**Item No. 9.1.2**  
**Design Review Committee**  
**November 21, 2022**

**SUBJECT:** **Case 24497: Substantive Site Plan Approval for 1190 Barrington Street,  
Halifax**

# Attachment A: Site Plan Approval Plans

Fig. 16. South Wind Existing  
EXISTING CONDITIONS

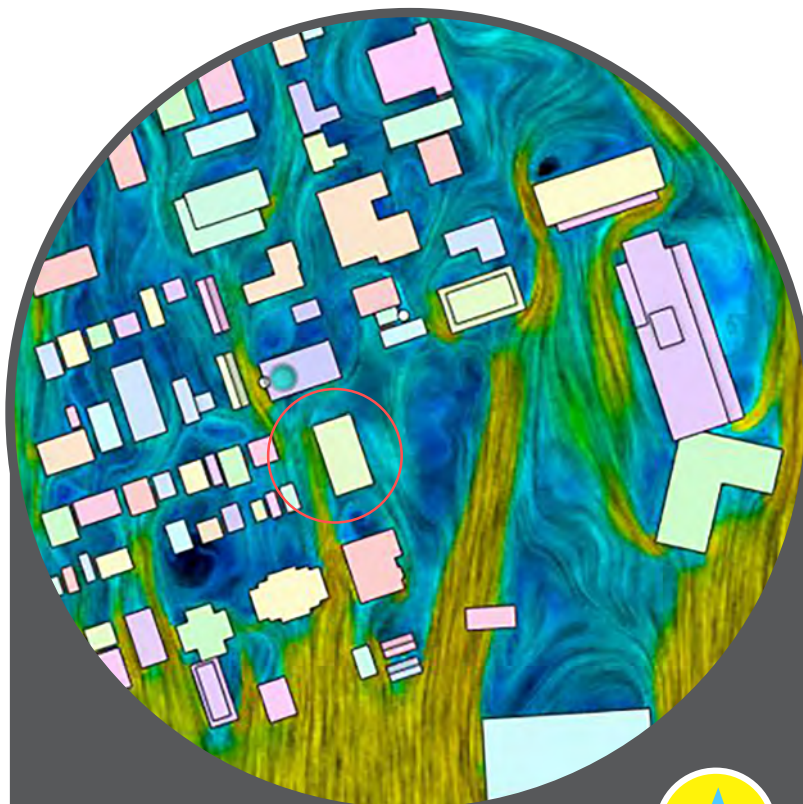
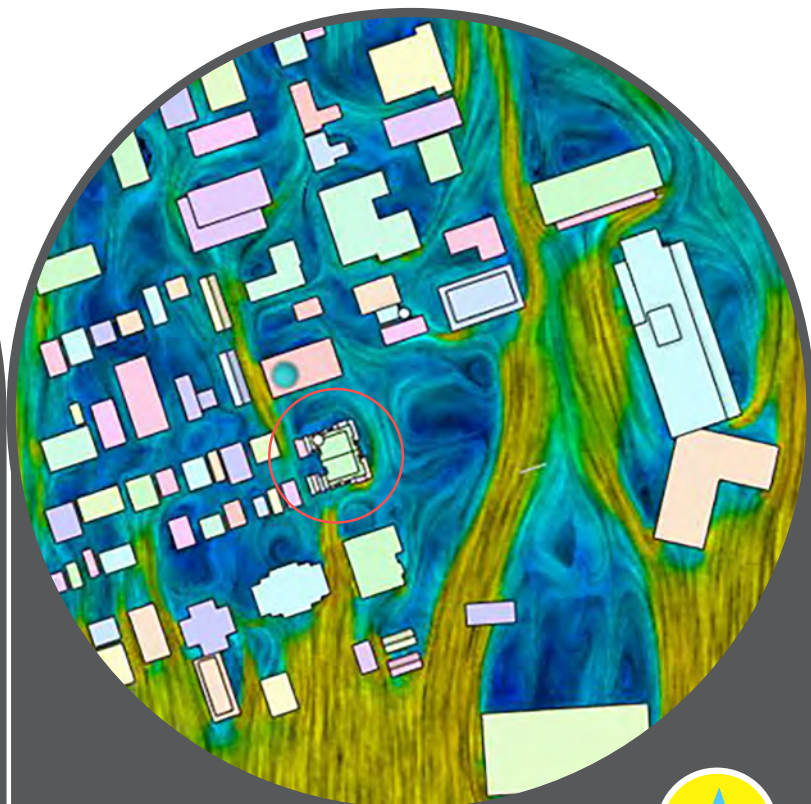
Looking at the existing and future conditions, winds from the south direction generally show very little change on wind speeds after the new building. There is slightly less windy conditions in Cornwallis Park as a result of the new building.

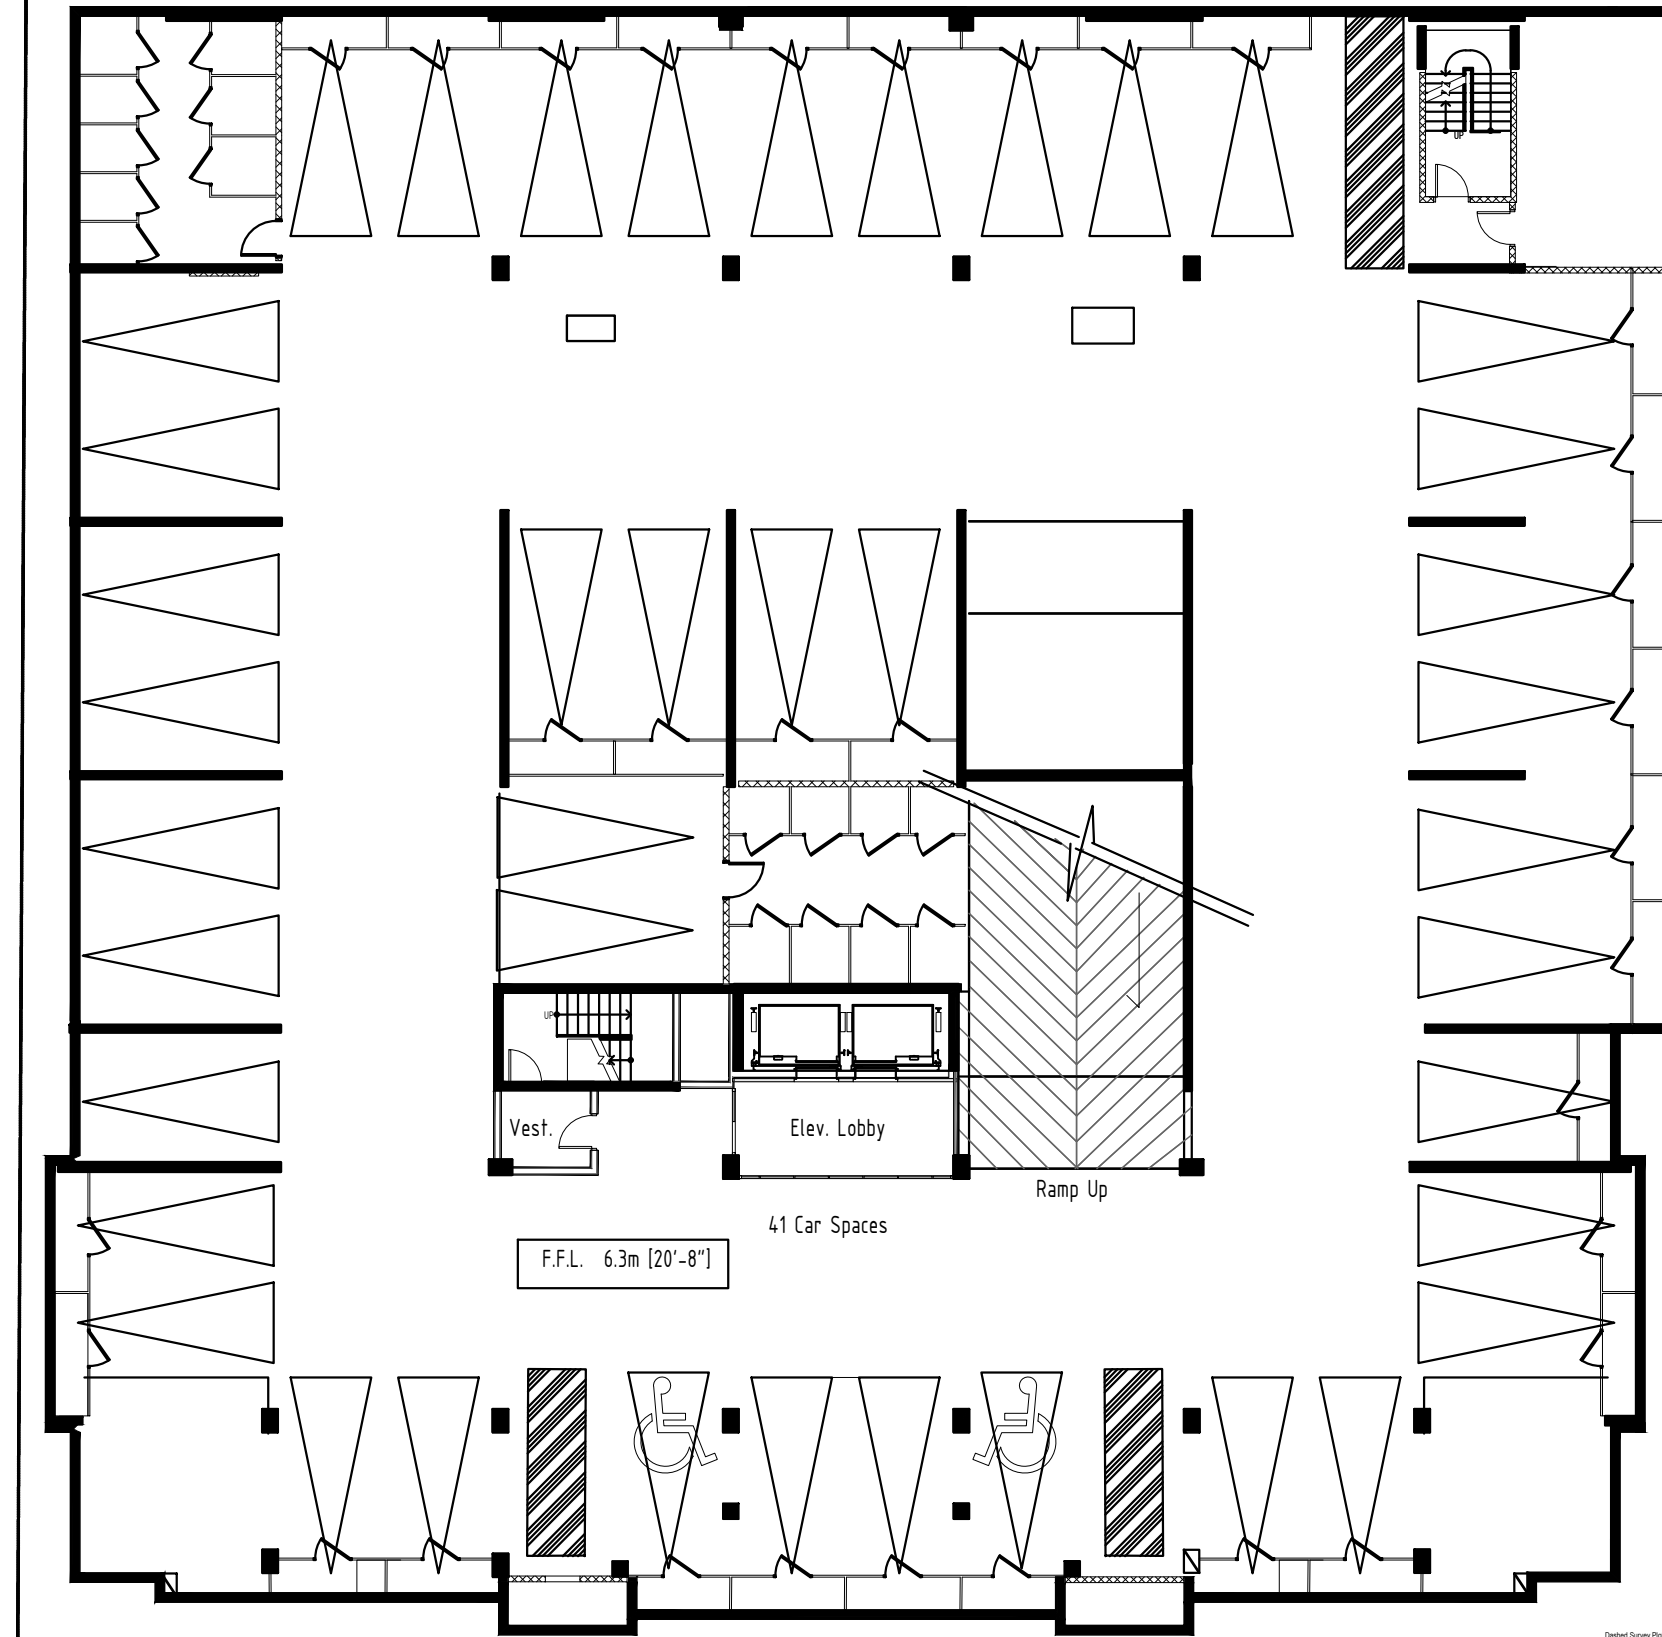
1. The setback at the 3rd and 4th storey surrounding the front of the building is important for reducing downdrafts on the surrounding neighbourhoods and streets.

2. The extended cantilevered patios create surface friction which helps to break up wind speeds from the north-west direction (prevailing winter).
3. The building articulation shown in the building design further reduces wind speeds at and near the street.

6. The wind shadows around the new building could add additional snow loading and drifting in Cornwallis Park but will generally be less windy than it is today.
